SUBJECT: INSPECTION 03036239/2003001, CFC LOGISTICS, INC., QUAKERTOWN,  
PENNSYLVANIA

INSPECTION REPORT

Inspection No. 03036239/2003001  
Docket No. 03036239  
Licensee: CFC Logistics, Inc.  
Location: 4000 AM Drive  
Quakertown, PA 18951  
Inspection Dates: February 13, 2003 through August 6, 2003

### FIGURE 3

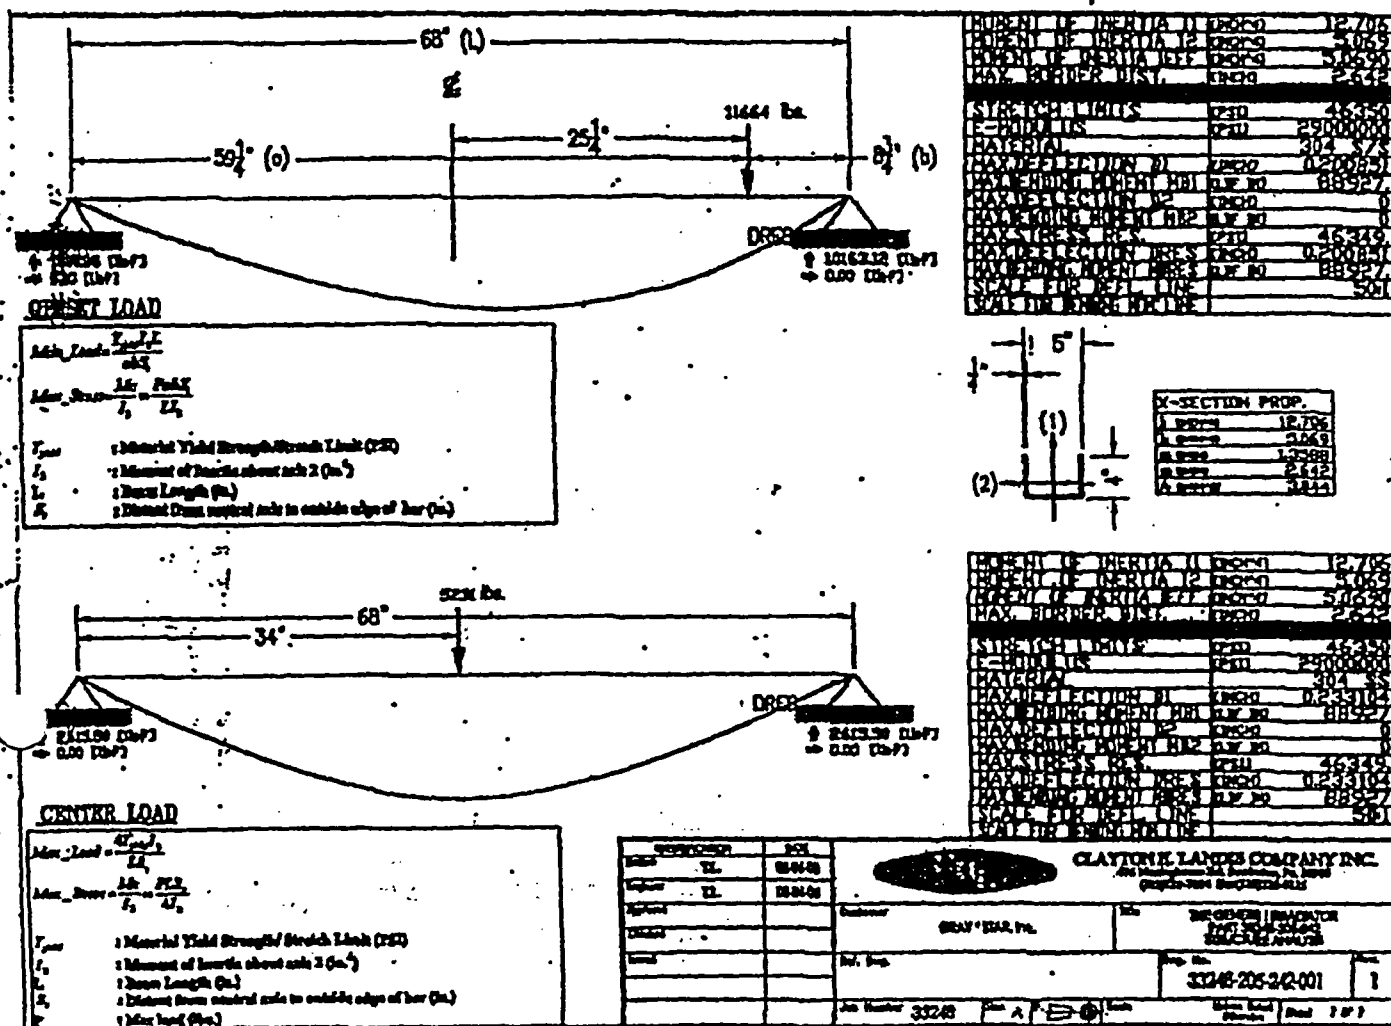
CHL drawing No. 33248-205-242-001, Rev 1, shown in Figure 3, presents a calculation of the strength of the lock bar showing vertical strengths of the lock bar to be 5231 lbs at its center line and 11664 lbs at 8.75 inches inside the inner pool edge. The vertical strength of the lock bar at its center line (5231 lbs) is less than the maximum weight (7,500 lbs) of a loaded bell. However, this is not of safety concern because if only one cable fails, the bell will swing and one of its lower edges will strike the lock bar at a point away from the center line. On the other hand, if both cables fail, the weight of the bell will be at the ends of the lock bar because the bell is open at the bottom. Furthermore, the lock bar also has extra support at each end that effectively reduces the "free" length of the bar to approximately 58 inches, which is less than the length of the bell (approximately 66 inches). Therefore the weight of a fallen bell will be on the sections of the lock bar that have additional support. Accordingly, the inspectors concluded that, under this scenario, damage to the pool liner resulting in loss of shielding or damage to the sources was not credible.
